SERVICE BULLETIN

APPLICABILITY: 2015-16MY Legacy and Outback Models
SUBJECT: Design Change to the Fuel Filler Door Assembly

NUMBER: 09-61-15R
DATE: 11/24/15
REVISED: 12/17/15

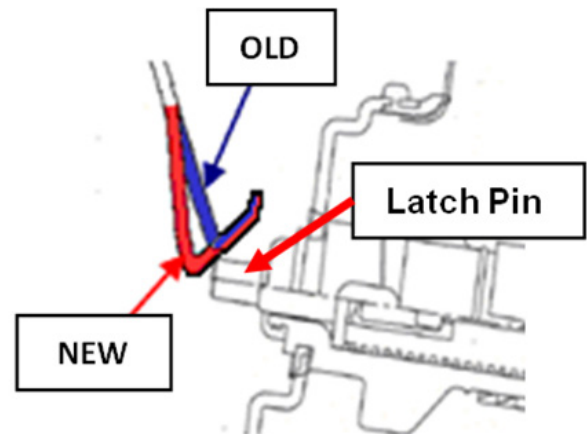
This bulletin announces a design change to the fuel filler door (saucer) assembly to address customer concerns of it being difficult to open and / or close. The striker portion's shape has been changed as shown in the cross-section illustration below along with the type of plastic material used in the construction of the saucer assembly.

If a complaint of the fuel filler door being hard to open or close is confirmed, replace the saucer and lock ring (seal) assembly along with a new "Unleaded Fuel Only" label using the applicable parts listed above. Follow the repair procedure outlined in the applicable Service Manual's Security and Locks section.
